## Response to the Reviewers' Comments

The authors would like to thank the reviewers for the precious comments and suggestions on the technical contents and presentation of our manuscript “Runtime Power Management of Battery Electric Vehicles for Extended Range with Consideration of Driving Time,” submitted to IEEE Transactions on Very Large Scale Integration (TVLSI.) This revised manuscript has been greatly improved thanks to the reviewers’ invaluable advices. We have revised the manuscript faithfully following the reviewers’s comments. We include the newly added or significantly modified parts in the revised version of the paper also in Response to Reviewers. We highlight the important technical content changes and set those parts in a red color in the revised paper.

Fig. 2: (a) Range-speed experimental data for Chevrolet Bolt [36] and (b) comparison with simulation results of the proposed EV power model.

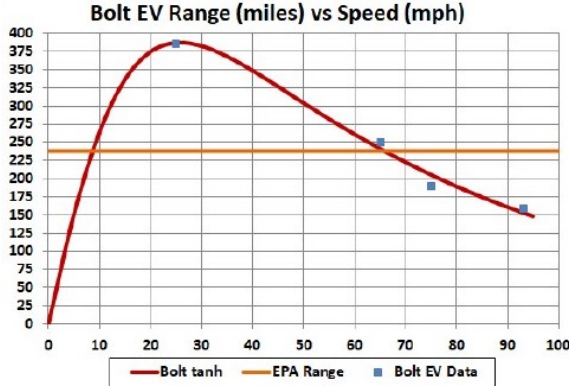
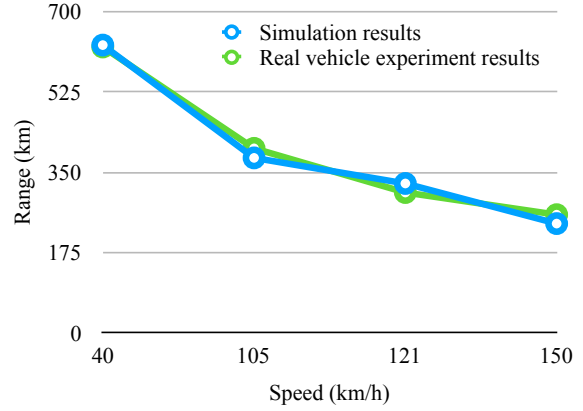
**R1-C2** It is not clear how to validate the power model of EV. As the author mentions that accuracy of power model is quite important, it is good to see the power model in this paper can be validated by some real measurement results.

Here goes how we extracted correct coefficients of the EV power equation. We use a vehicle simulator that supports EV as well, ADVISOR, to extract the coefficients of new vehicles starting from known vehicle specifications such as the aerodynamic resistance, rolling resistance, curb weight, and so on. Such data is often published in the users' manual, website and so forth. We further use the vehicle performance data such as the top speed, maximum acceleration, and so on, which are also available on the manuals and website. We iteratively run ADVISOR and derive the model coefficients so that all the known values match among each other. We evaluate the model accuracy with the range-speed real vehicle experiments as shown in Fig. 1(a), which has been published by [32], [33], [34], [35], [36]. We further refine the coefficients until all the available data values match well. Finally, the derived EV power model well matches with the range-speed experimental data as shown in Fig. 1(b) as well as the top speed and maximum acceleration, setting the aerodynamic resistance, rolling resistance, curb weight, etc. with the known (fact) values. The errors of the range-speed simulation is merely 1.4%, the time to approach 60 mph at departure is 7.8%, and the top speed is 3.0%, respectively. We revised the manuscript adding the following paragraph with a new figure in Section III.A on page 3 and 4.

We use ADVISOR to extract the model coefficients of new vehicles starting from known vehicle specifications such as the aerodynamic resistance, rolling resistance, curb weight, and so on. Such data is often published in the users' manual, website and so forth. We further use the vehicle performance data such as the top speed, maximum acceleration, and so on, which are also available on the manuals, commercials and websites. We iteratively run ADVISOR and derive the model coefficients so that all the known data values match among each other. The model coefficient extraction result shows as in Fig. 1. The normalized root-mean-square (RMS) deviation is 5.1%. Table I summarizes the model coefficients of (5) for Chevrolet Bolt.

We further evaluate the model accuracy with the range-speed real vehicle experiments as shown in Fig. 2(a) to confirm the derived power models are close enough to the real vehicle measurement data [32], [33], [34], [35], [36]. We refine the coefficients until all the available data values match well.

As a result, the derived EV power model well matches with the range-speed experimental data as shown in Fig. 2(b) as well as the top speed and maximum acceleration setting the aerodynamic resistance, rolling resistance, curb weight, etc. with the known values. The errors in the range-speed simulation is merely 1.4%, the time for 0-to-100 km/h error is 7.8%, and the top speed error is 3.0%, respectively.

Fig. 12: Velocity profile comparison with  $EDP$ ,  $E^2DP$  and  $E^3DP$  on Serrano Avenue in Anaheim Hills.

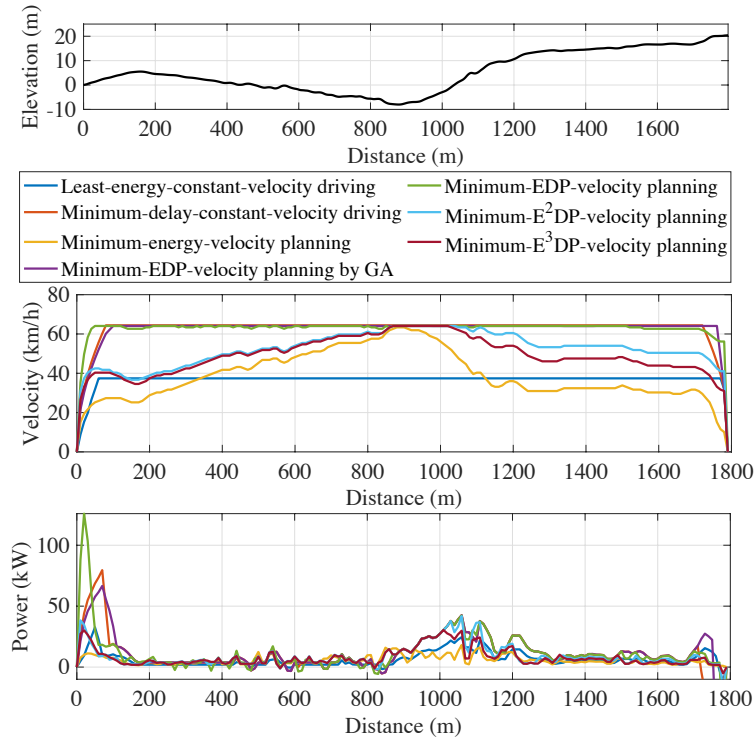
**R1-C3** The optimality of the proposed scheduling algorithm is unclear. The author should add several paragraphs to discuss this topic. It is also to see the comparison baseline is well accepted to show the advantage of the proposed algorithm.

Fig. 12 summarizes  $EDP$  of the least-energy-constant-velocity driving, the minimum-delay-constant-velocity driving, the minimum-energy-velocity planning, the velocity planning with  $EDP$ ,  $E^2DP$  and  $E^3DP$  as a metric on the road benchmarks and the minimum- $EDP$ -velocity planning with GA. The proposed velocity planning results in up to 46.2% improvements of  $EDP$  compared with the least-energy-constant-velocity driving. The driving velocity on a flat road is faster than that of the least-energy-constant-velocity driving at the expense of relatively little energy to save driving time. Then, the velocity decreases when climbing the following uphill to spend less motor torque, which saves more energy.

In addition,  $EDP$  of the proposed EDP-aware-velocity planning is merely 4.3% higher than that of the true EDP-minimum-velocity planning on average. Through this results, we confirm that the results of the proposed heuristics are close enough to the true optimal solutions.

We also updated Fig. 12 and Fig. 13:

Fig. 11: Histograms of velocity and acceleration for the proposed energy-aware-velocity planning methods without an acceleration constraint (a) and (b) and with an acceleration constraint (c) and (d), respectively.

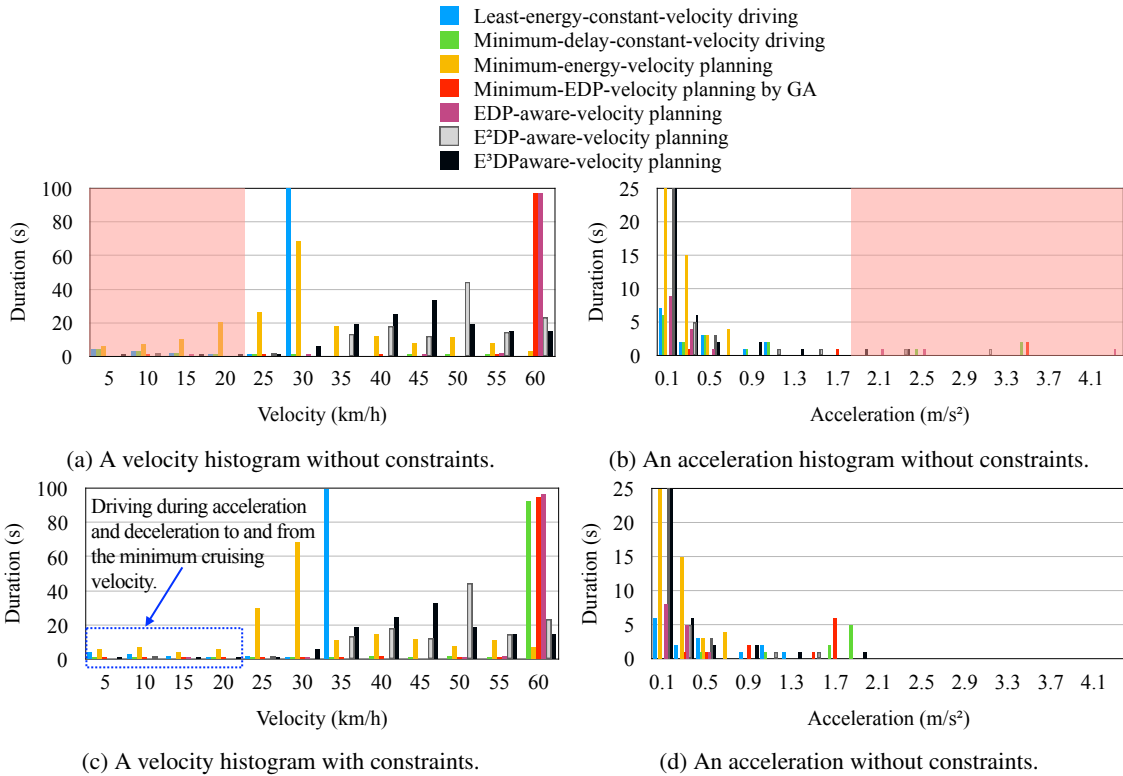
**R2-C2** It would be good to have more discussion on the assumptions of the approach and the experiments, e.g., how much can the velocity be changed in practical scenarios without impeding traffic and causing unsafe situations (also depending on the road conditions and whether it is urban or rural environment I suppose). Currently, there only seems to be one constraint on not slower than 10 km/h.

Fig. 11(a) and (b) show two histograms of the driving schemes in Fig. 12, which do not have velocity and acceleration constraints. We avoid a cruising velocity lower than 25 km/h and an acceleration higher than  $2.0 \text{ m/s}^2$  in this paper without loss of generality. The acceleration of  $2.0 \text{ m/s}^2$  is the same as the maximum acceleration of compact cars designed to be used primarily used in urban areas (13 seconds of 0 to 100 km/h time).

Fig. 11(c) and (d) shows the velocity and acceleration histograms with the constraints. Once we run the DP for the first time without constraints, we analyze the histogram, adaptively determine the minimum cruising velocity and maximum acceleration constraints, and run DP again. We keep the same constraints for online recomputation whenever unexpected interrupts occurs.

We quantize the velocity and acceleration values and make a histogram to analyze population of velocity and acceleration for the proposed energy-aware-velocity planning methods. Fig. 11(a) and (b) show two histograms of the driving schemes in Fig. 12, which do not have velocity and acceleration constraints. We avoid a cruising velocity lower than 25 km/h and an acceleration higher than  $2.0 \text{ m/s}^2$  in this paper without loss of generality. The acceleration of  $2.0 \text{ m/s}^2$  is the same as the maximum acceleration of compact cars designed to be used primarily used in urban areas (13 seconds of 0 to 100 km/h time).

Fig. 11(c) and (d) shows the velocity and acceleration histograms with the constraints. Once we run the DP for the first time without constraints, we analyze the histogram, adaptively determine the minimum cruising velocity and maximum acceleration constraints, and run DP again. We keep the same constraints for online recomputation whenever unexpected interrupts occurs.

Fig. 8: Altitude changes in the real road benchmarks.

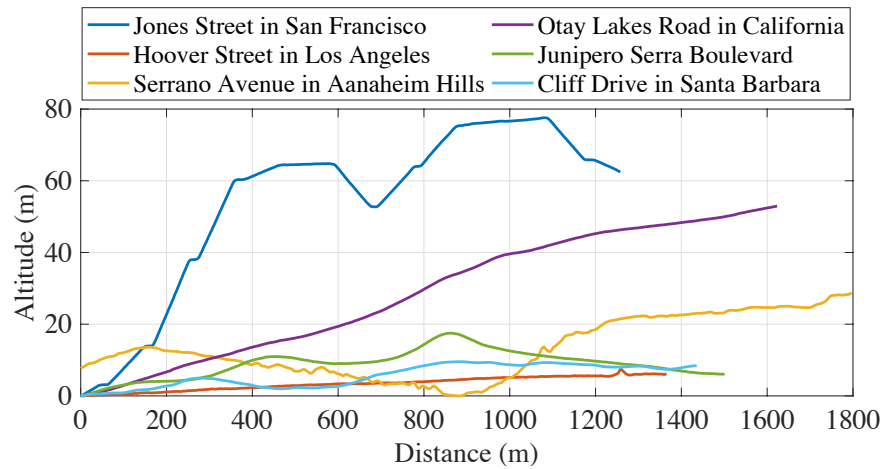
**R2-C3** Related to the last point, it would be good to have more discussion on the road benchmarks, e.g., how they are generated and how representative they are. The optimization results significantly depend on road slope. It would be good to use a variety of real road segments for testing.

**R2-A3** We appreciate the reviewer's comment. We replaced the previous synthetic road benchmarks with the real road benchmarks. We made six new real road benchmarks from various locations in California. The first three roads are in cities. Jones Street in San Francisco and Hoover Street in Los Angeles are two representative city landscapes such as hills and flat roads, respectively, and Cliff Drive in Santa Barbara is a mixture of those. The second two roads are in mountain areas: Serrano Avenue in Anaheim Hills and Otay Lakes Road in San Ysidro

Mountain in California. The last road is Junipero Serra Boulevard connecting San Francisco and San Jose. The details of road data is summarized in Table II, and Fig. 8, which visualize the altitudes of the road benchmarks. We also revised all the associated contents with the new real road benchmarks.

We choose six roads from various locations in California and make real road benchmarks. The first three roads are in cities. Jones Street in San Francisco and Hoover Street in Los Angeles are two representative city landscapes such as hills and flat roads, respectively, and Cliff Drive in Santa Barbara is a mixture of those. The second two roads are in mountain areas: Serrano Avenue in Anaheim Hills and Otay Lakes Road in San Ysidro Mountain in California. The last road is Junipero Serra Boulevard connecting San Francisco and San Jose. The details of road data is summarized in Table II, and Fig. 8, which visualize the altitudes of the road benchmarks.
